Groundwater Application Review Summary Form

Application # G- G-19043

GW Reviewer Darrick E. Boschmann Date Review Completed: 08/29/2024

Groundwater Permit Application G-19043 Colahan Enterprises Inc. / Erin Douglas

D1. Well #: 2 Logid: LAKE 1628/1626/52582 (Little Hot Well)

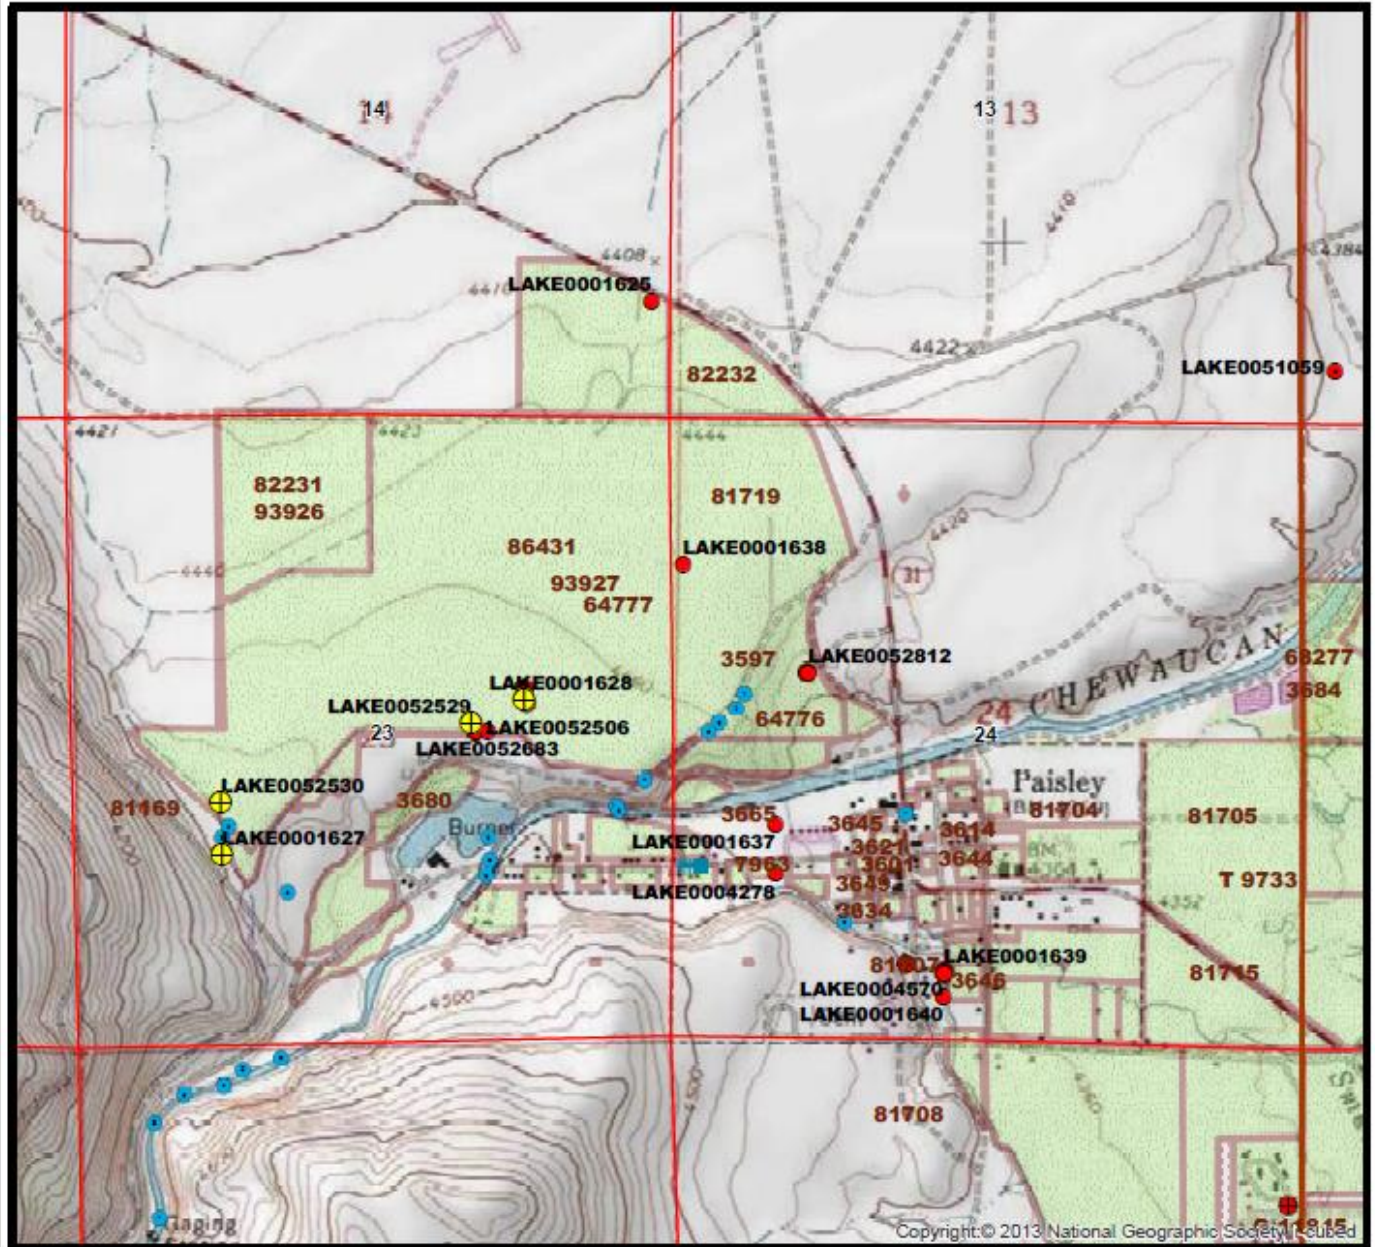
D2. **THE WELL does not appear to meet current well construction standards based upon:**

Watermaster Brian Mayer previously noted a video log of well LAKE 1628/1626/52582 (Little Hot Well) indicates the well has caved-in from 432 ft. depth to the casing bottom (270 ft. depth). The Department has previously recommended abandoning and replacing the well. Surprise Valley Electric has attempted a replacement with LAKE 52506 (SVE #4).

D4. **Route to the Well Construction and Compliance Section for a review of existing well construction.**

Hydrographs of Water-Level Measurements in Vicinity Wells

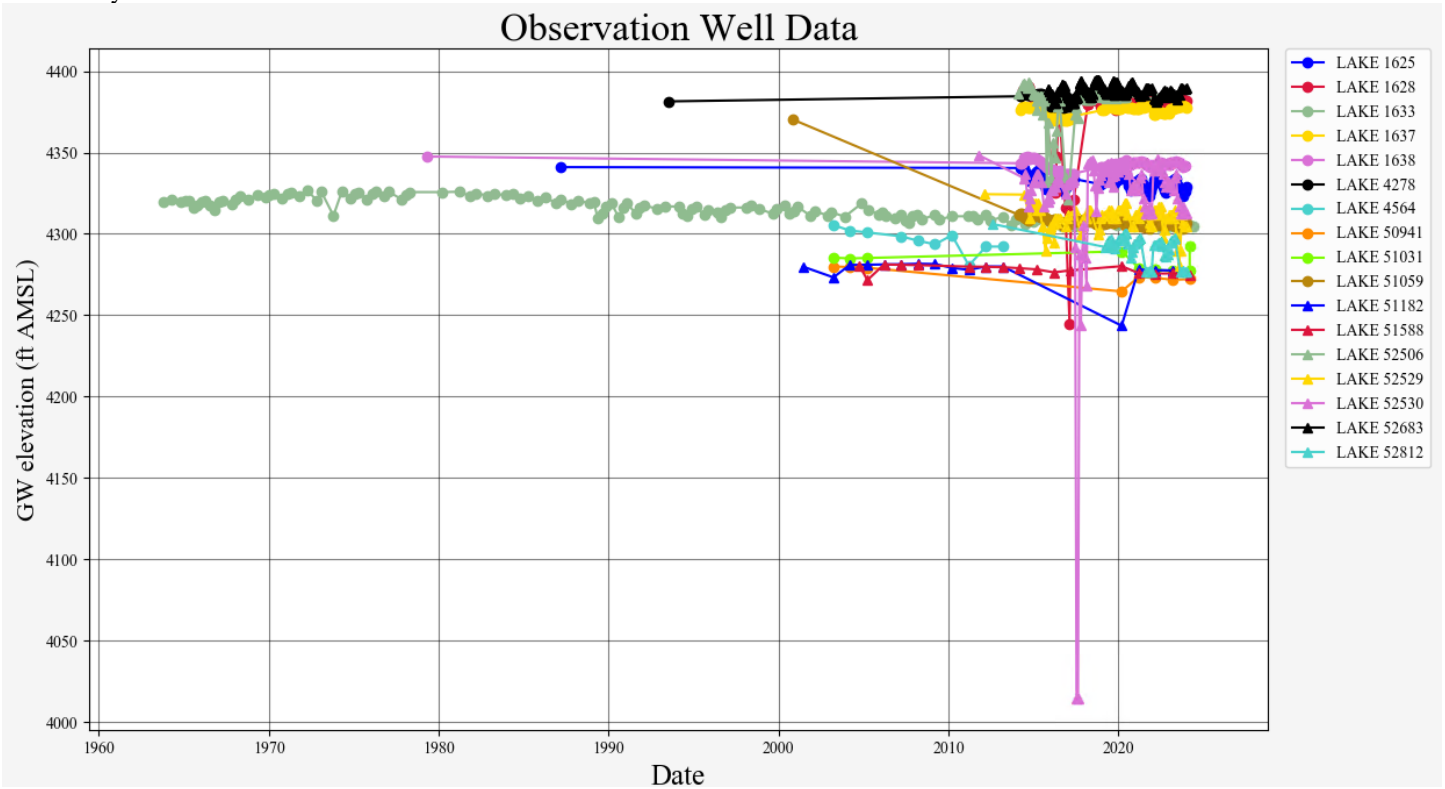
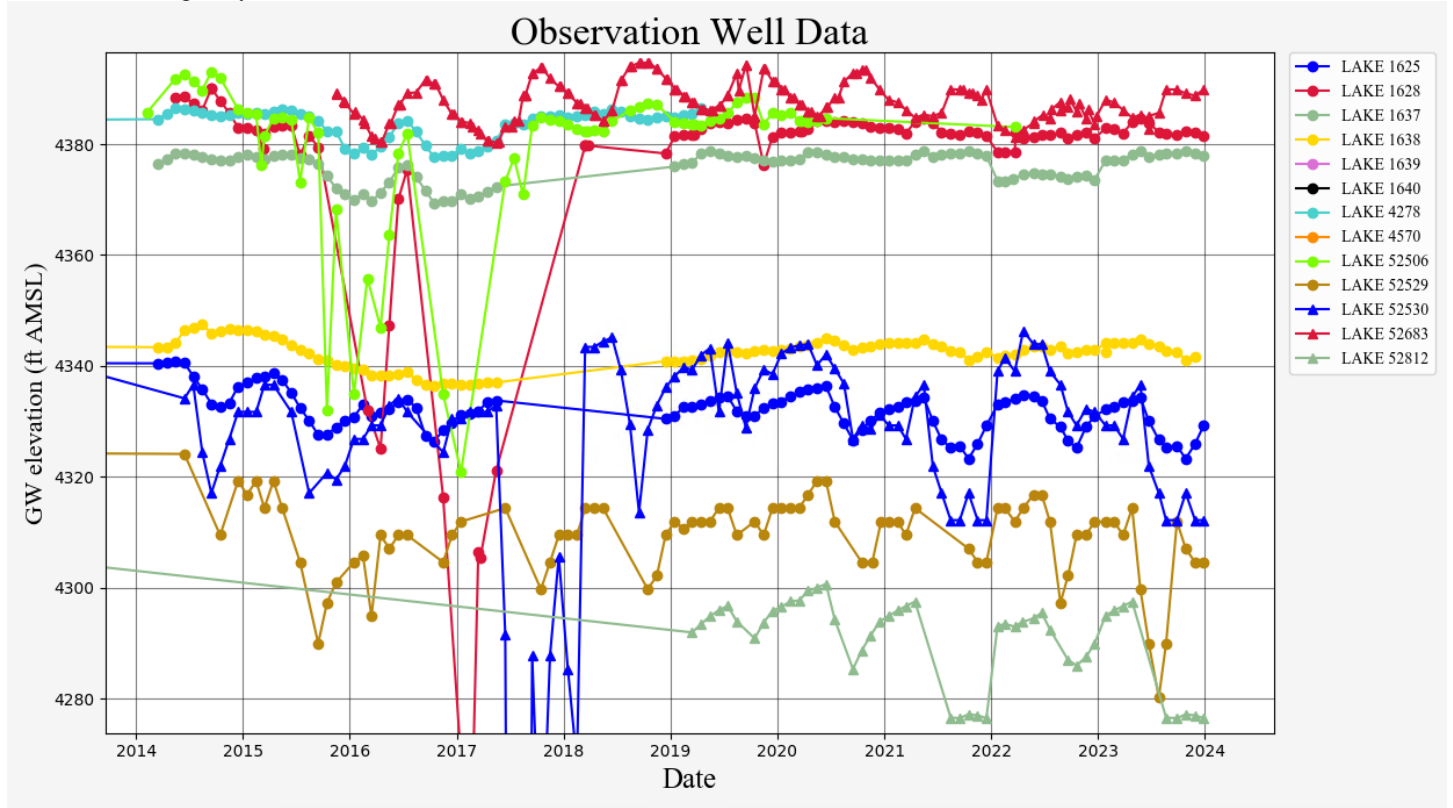
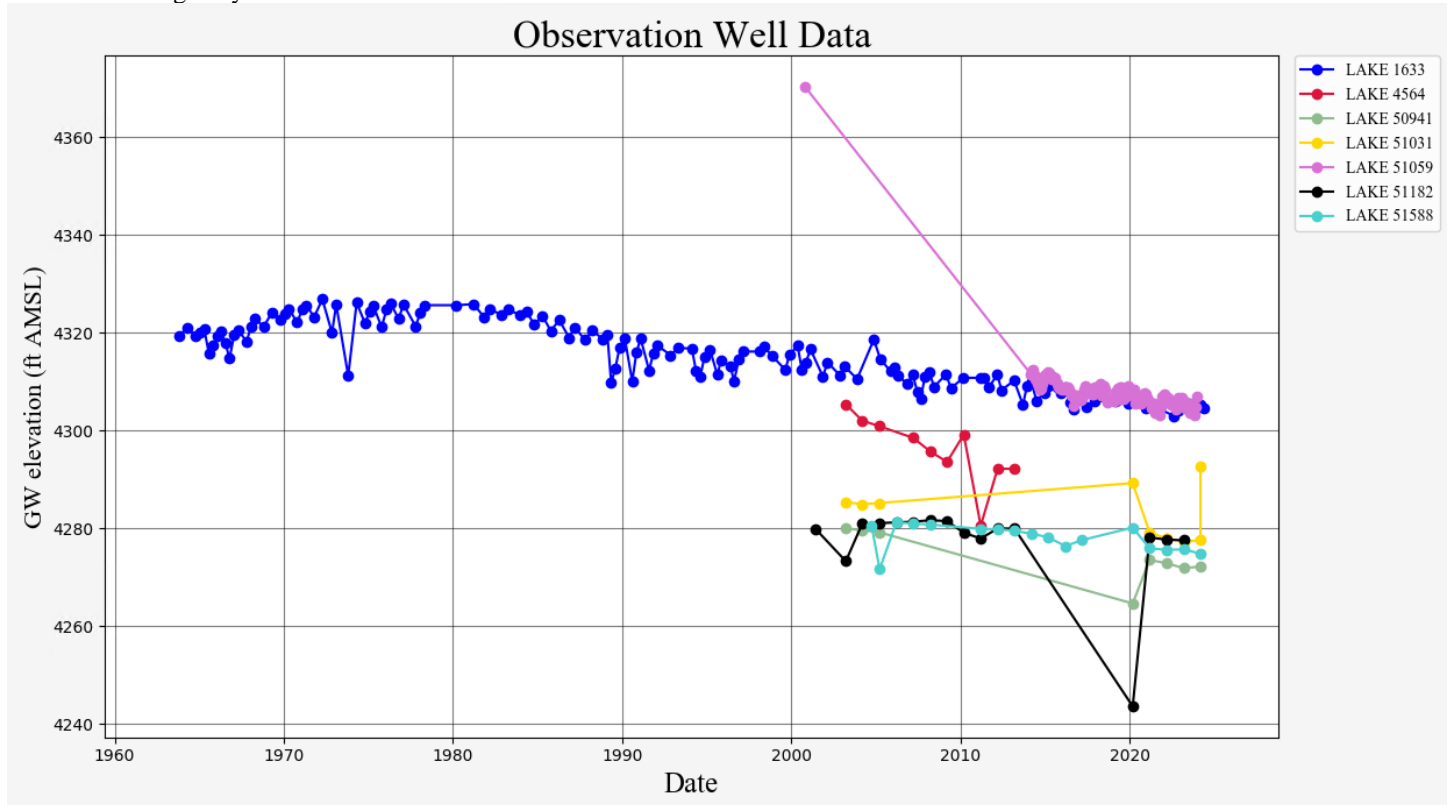
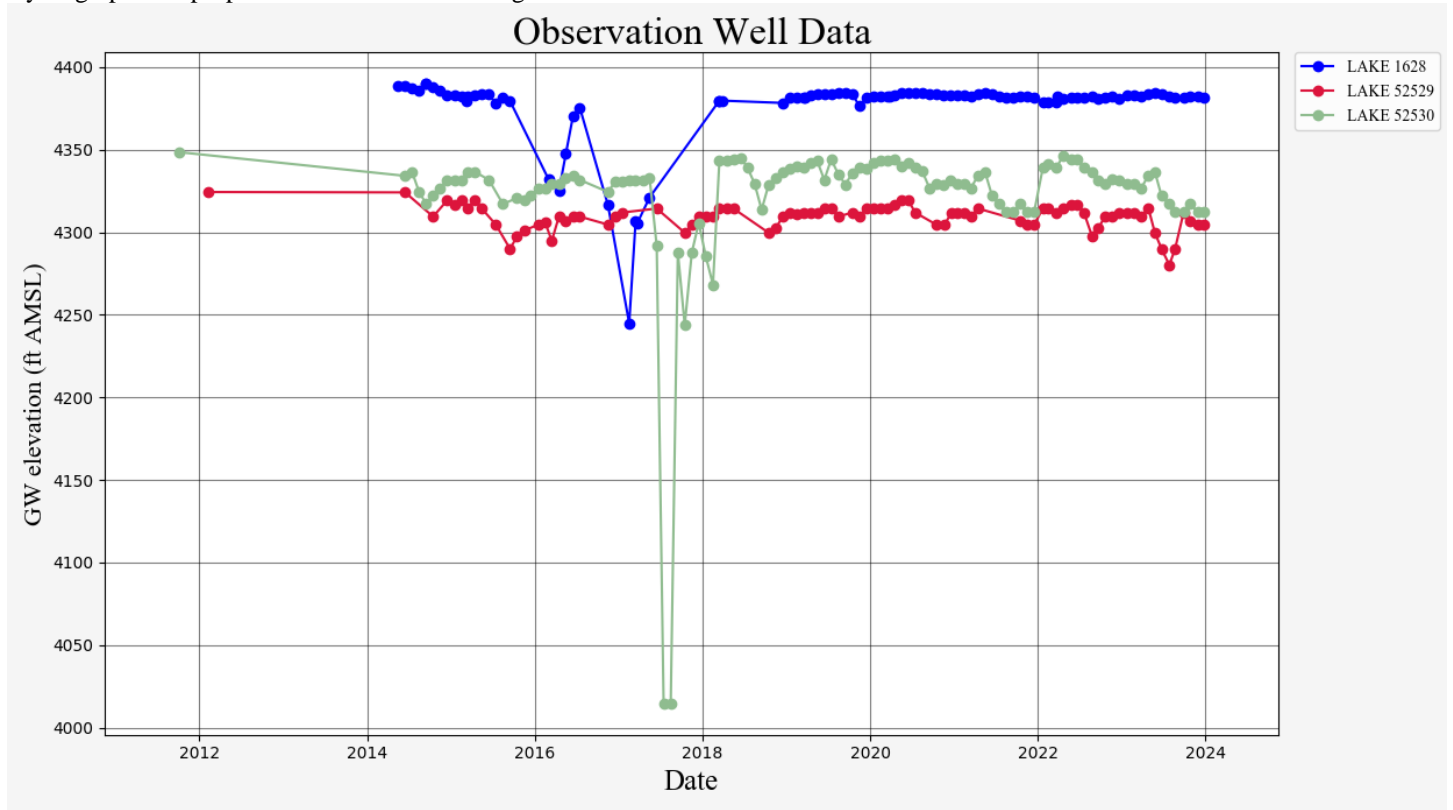
The available water level record does not meet the Division 8 definition of excessively declining or declined excessively (for the storage portion of the source of water to wells). See attached hydrographs.

LAKE 1628 to Chewaucan River

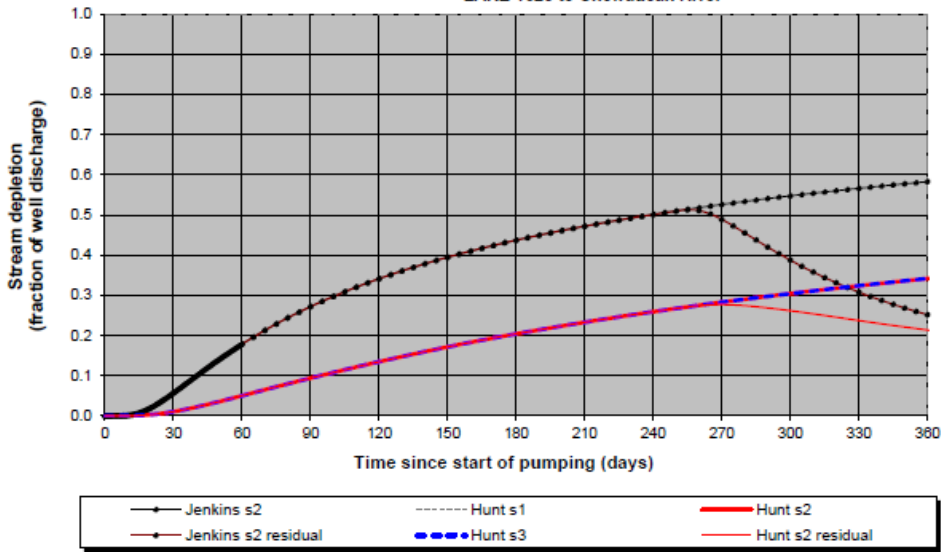
The requested rate is greater than 1% of the 80% natural flow for the Chewaucan River, and therefore PSI is assumed for well 2 to the Chewaucan River. Note that the values in table C3a have not changed from the original 11/19/2021 review, however the findings in the table are made consistent with the relevant evaluations.

Hunt (1999) was used to calculate groundwater interference with surface water given the POD well obtains groundwater from the predominantly basin-fill unit which is in direct contact with the river. The calculation used the full rate requested (1.66 cfs) given the application appears to request being able to use up to 1.66 cfs at any combination of POD wells including a single POD well. The calculation used an average basin fill transmissivity of 115 ft²/day for the predominantly basin fill (see attached transmissivity calculation summary) and an intermediate storage coefficient of 0.001.

LAKE 52529 to Chewaucan River

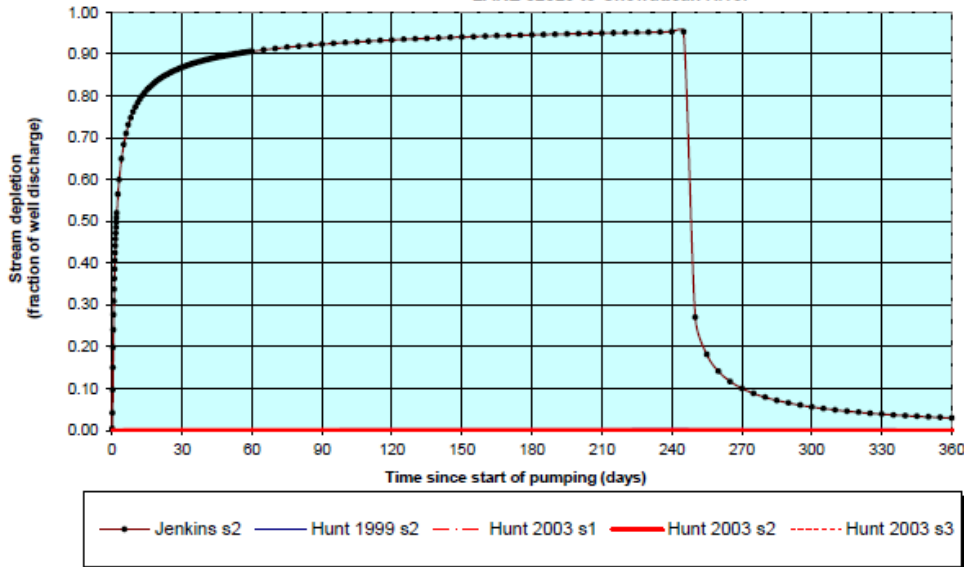
Wells LAKE 1627/4448 (Well #1), LAKE 52530/52866 (SVE #1), and LAKE 52529/52865 (SVE #2) are more than one-mile from the estimated groundwater level-river level intercept. Hunt (2003) was used to calculate groundwater interference with surface water given the POD wells obtain groundwater from the predominantly volcanic rock and sediment unit which is hydraulically connected to the river through the overlying predominantly basin-fill unit. The calculation used the full rate requested (1.66 cfs) at the closest well (LAKE 52529) given the application appears to request being able to use up to 1.66 cfs at any combination of POD wells including a single POD well. Additionally, the calculation represents the maximum possible interference. The calculation used an average basin fill transmissivity of 18,000 ft²/day for the predominantly volcanic rock and sediment unit (see attached transmissivity calculation summary) and an intermediate storage coefficient of 0.001. The results do not exceed one percent of the natural river flow for any month.
